Access Compliance Report

Public Rights-of-Way

(Curb Ramps)

Intersection ID: N/A	Main Street: NATIONS_FORD_RD	Cross Street: N/A	Location: N
ADA ID: 310AF371B3AC	Ramp Type: PerpDiag	Initial Pass/Fail: Fail	Overall Compliance: No
			Severity Score: 21.25

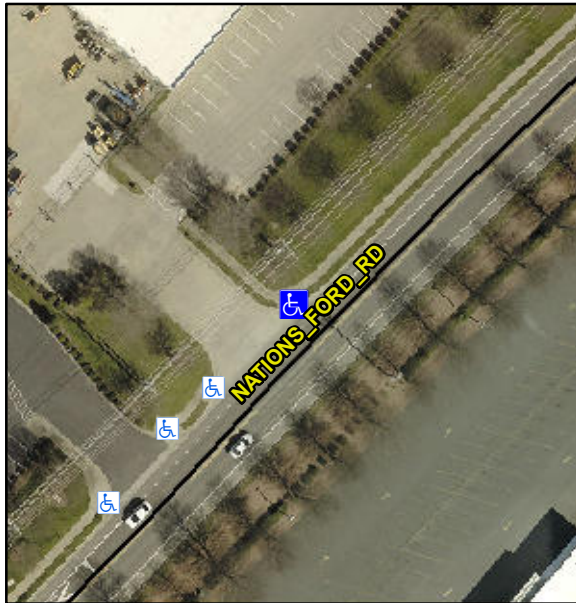
R304.5.1, R304.5.3

Compliance	Description	Data	Compliance	Description	Data
N/A	Ramp Length (in)	106.0	Yes	Ramp Slope (%)	7.2
No	Ramp Width (in)	45.0	No	Ramp XSlope (%)	6.3
N/A	Flare Type LT	N/A	N/A	Flare Type RT	N/A
N/A	Flare Slope LT (%)	N/A	N/A	Flare Slope RT (%)	N/A
N/A	Flare Traversable LT?	N/A	N/A	Flare Traversable RT?	N/A
N/A	Landing Length (in)	N/A	N/A	DWS Provided?	N/A
N/A	Landing Width (in)	N/A	N/A	DWS Contrast?	N/A
N/A	Landing Slope (%)	N/A	N/A	DWS Length (in)	N/A
N/A	Landing X Slope (%)	N/A	N/A	DWS Full Width?	N/A
N/A	Landing Curb? (Y/N)	N/A	N/A	DWS Offset (in)	N/A
N/A	Shared Landing?	N/A			
N/A	Gutter Ponding?	N/A	N/A	Gutter Slope (%)	N/A
N/A	Gutter Lip Ht (in)	N/A	N/A	Gutter X Slope (%)	N/A
N/A	Painted X Walk1?	No	N/A	Painted X Walk2?	No
	X Walk 1 Direction	To SW		X Walk 2 Direction	To SE
N/A	X Walk 1 Width (in)	N/A	N/A	X Walk 2 Width (in)	N/A
	X Walk 1 Slope (%)	0.4		X Walk 2 Slope (%)	3.6
	X Walk 1 X Slope (%)	2.0		X Walk 2 X Slope (%)	3.5

Remove & Replace Curb Ramp With Two New Directional Ramps or Equivalent.
